Indianapolis Historic Preservation Commission (IHPC)
HEARING AGENDA

Wednesday, February 7, 2024, 5:30 P.M.
2nd Floor, Public Assembly Room, City-County Building
200 E. Washington St., Indianapolis, Indiana

COMMISSION HEARING MINUTES

Proposed front (east) elevation (Applicant's/owner's preferred option)

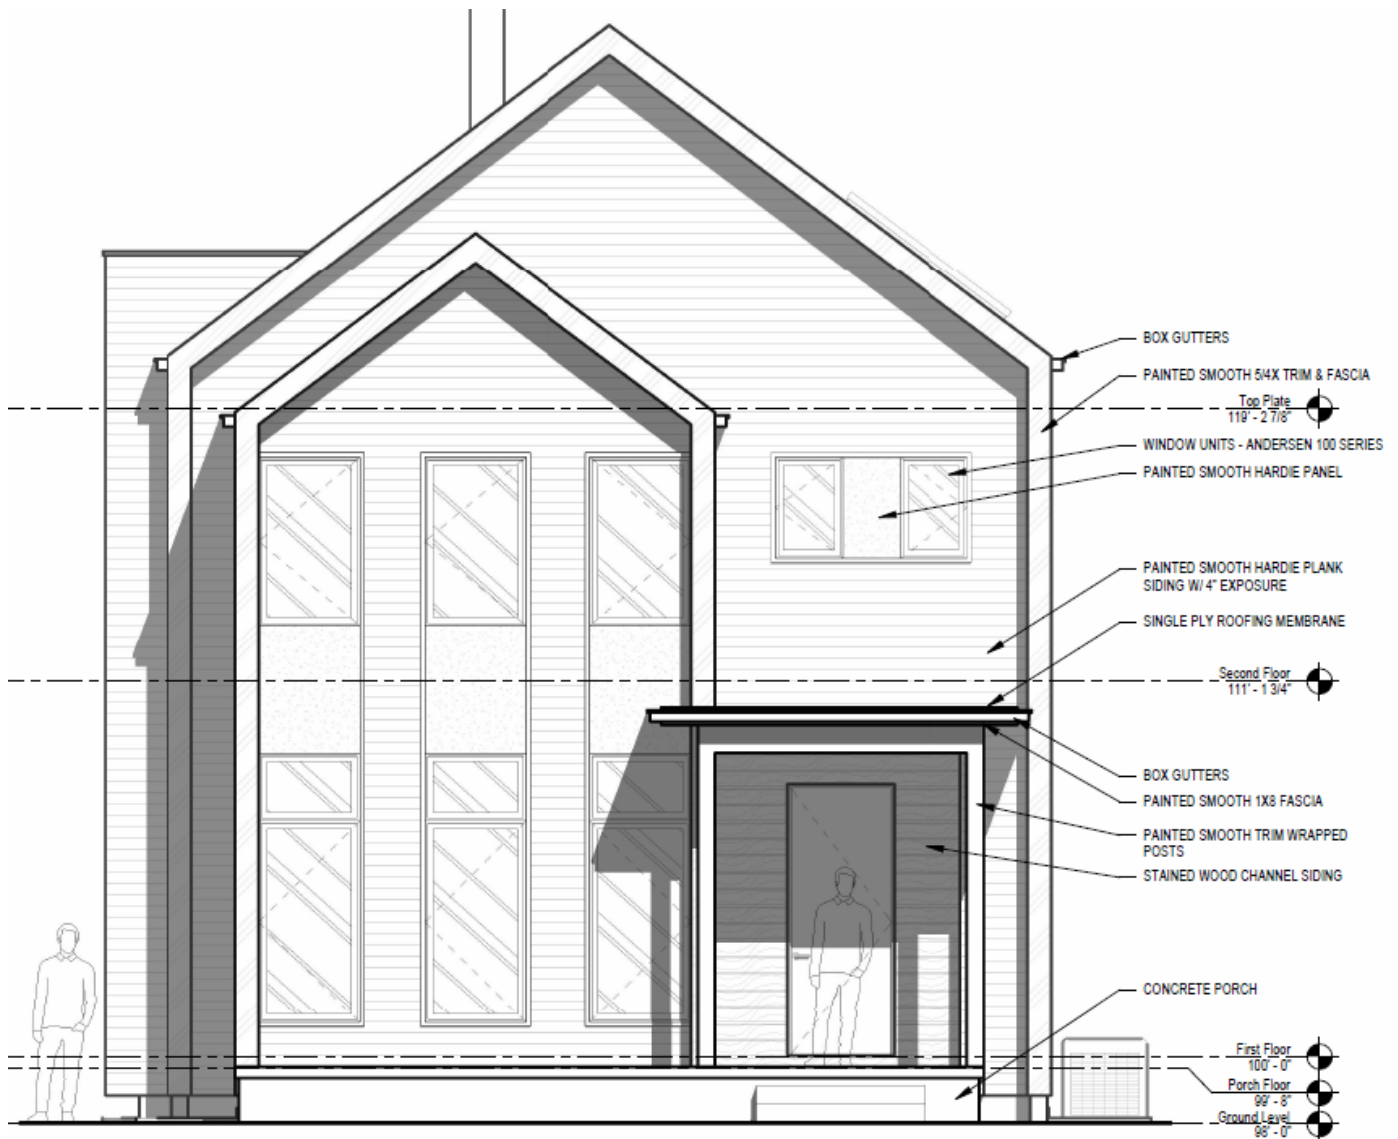
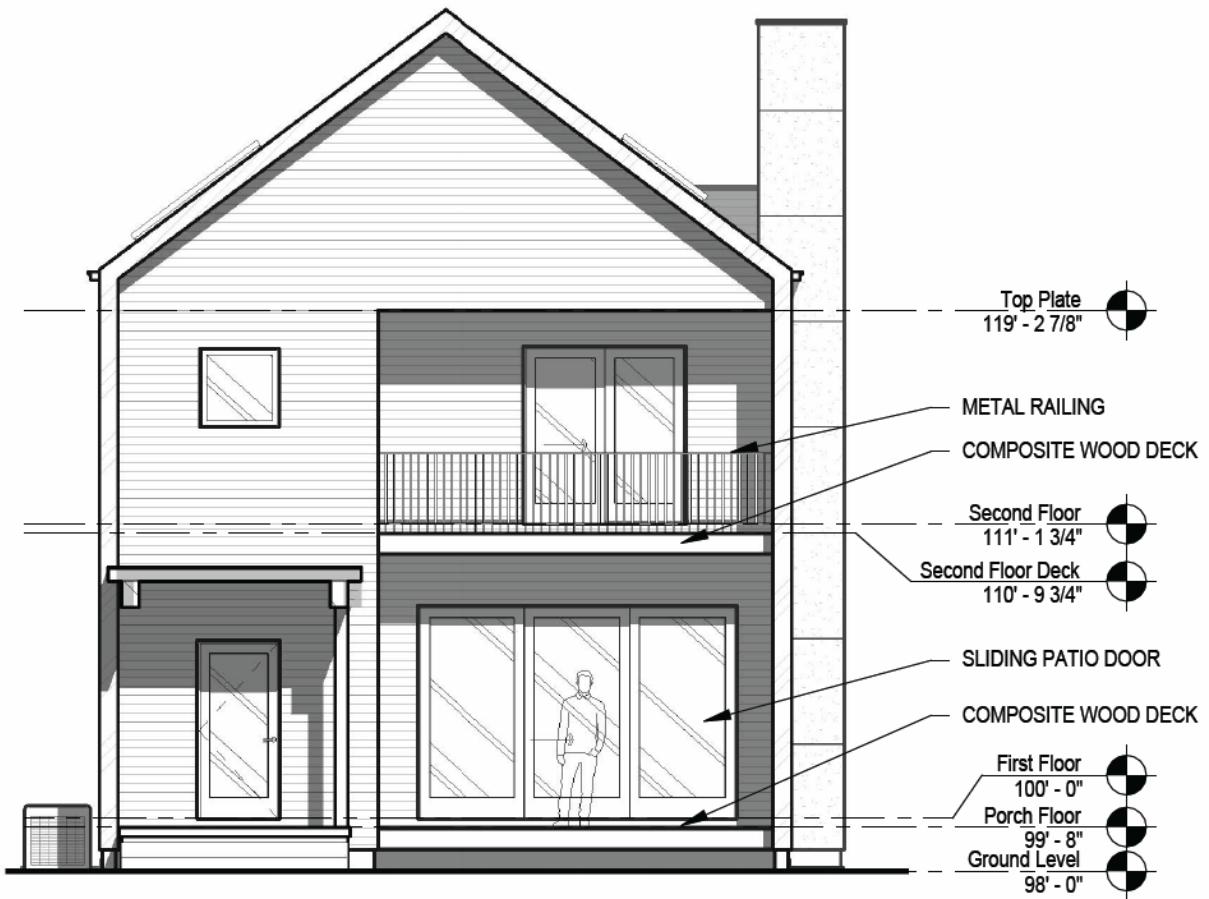
Conversely, Staff does not find that the outline, materials, fenestration, style and design reflect the Plan's recommendations for new construction. Nor does Staff believe that the overall style and design respect the historic and traditional character of the neighborhood. Staff recommends significant changes to the project so that it will satisfy the recommendations written and illustrated in the Plans; and to also respect the historic, traditional characteristics of the immediate context. Therefore, Staff is recommending a continuance of the case, so that the applicant and his clients may work together to implement those changes.

- The combination of the first three elements causes the south side of the house to feel heavy and a bit lopsided.
 - The garage's T-plan is uncharacteristic for garage accessory structures between the 1600-1800 blocks.

To conclude, the Herron-Morton Place LUC has some concerns regarding this design, based on the stipulation in the HMP Historic Preservation Plan that new construction *on an isolated site* should “reflect the design trends and concepts of the period in which it is created,” while also being “in harmony with the old.” While the proposed design succeeds with the former, we believe that it falls short of the latter.

To continue the COA request until the March 6, 2024, Commission hearing to allow for the applicant and his clients time to incorporate any recommended changes discussed by the Commission at the February 7, 2024, hearing.

SIDING & CORNICE INSTALLED

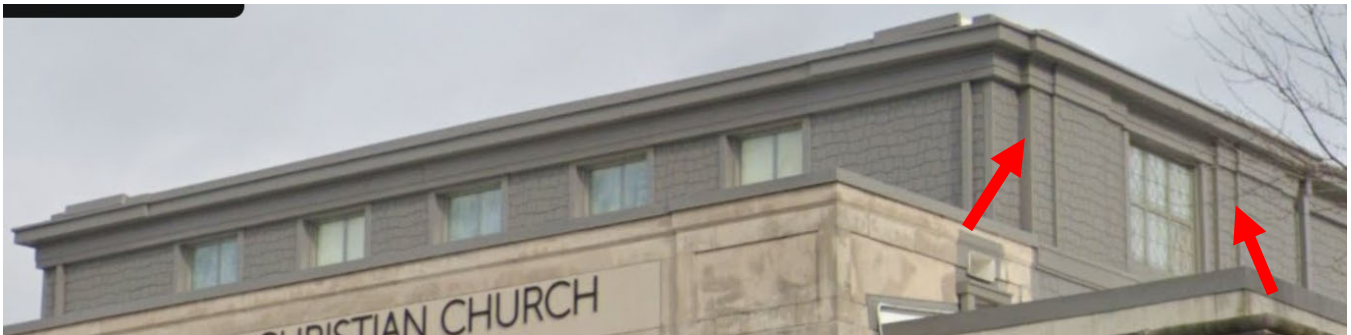
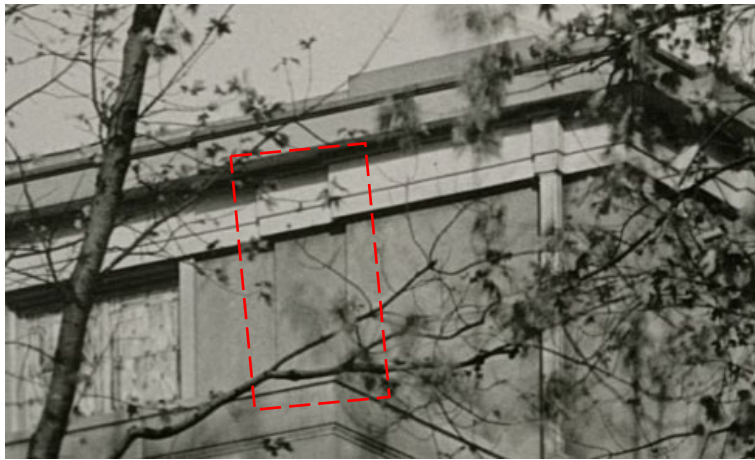
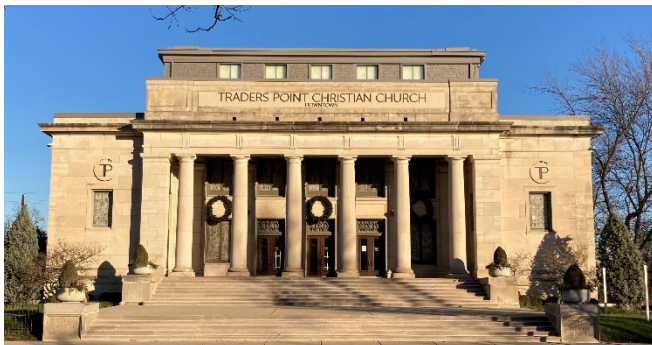
In reviewing images of the building for the January 2024 Commission hearing report, staff noticed differences between the previous clerestory cornice wrap and the replacement that was installed. The cornice had two insets on the west/front elevation that were not replicated in the new wrap. This change in the profile of the cornice was not permitted by the COA, and so that portion of the work was added to this request.

Staff finds the request to maintain the non-matching, rusticated shake siding and non-matching cornice wrap on the clerestory to be in direct conflict with the district plan and is recommending denial of the request.

The alteration of a cornice profile is in direct conflict with the plan. Cornices are an important element of a roof's historic character and are to be maintained. It appears that the area had alterations prior to this work taking place, but in the event historic materials have been previously altered or removed they should be restored when new work takes place.

To deny a Certificate of Appropriateness or Authorization to maintain the replacement shingle siding on the west and south sides of clerestory and denial to retain non-matching metal cornice wrap as installed without approval.

Siding and cornice wrap must be replaced with appropriate materials to match the previous material per original COA no later than August 7, 2024. The applicant must receive approval from IHPC staff for the new product, prior to purchase and installation. *Approved* _____ *Date* _____

Fencing that was replaced (Staff has not been able to locate an approval for this installation – present since at least 2009)

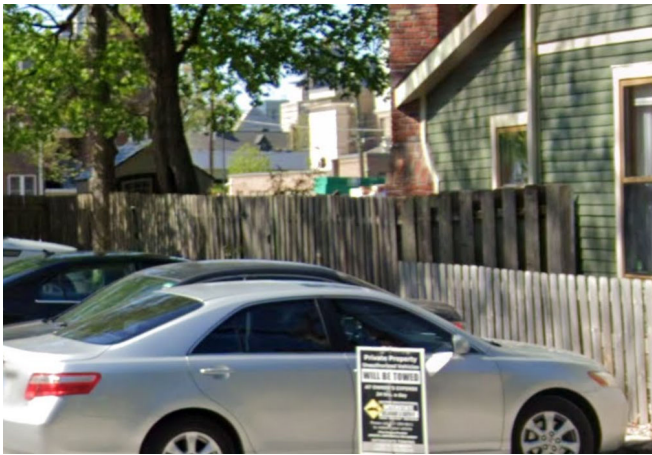
In all the historic district plans that specify fence types that are appropriate for the districts, shadow box fencing is specifically called out as inappropriate. Therefore, it is standard practice of IHPC staff to recommend against its use in the districts and suggest different styles that are that appropriate to applicants. It is staff's understanding that these recommendations were included in the plans because shadow box fencing is considered to be a suburban style and therefore inappropriate in the urban context of the districts. Staff defers to the Commission on if it finds shadow box fencing to still be an inappropriate product and have included two options for recommended motions depending on the Commission's determination.

To approve a Certificate of Appropriateness to maintain the new shadow box fence installed without approval, per submitted documentation and subject to the following stipulations:

1. Any deviation from this approach shall be approved by IHPC staff prior to work taking place.
2. Notify IHPC staff prior to making unexpected repairs.
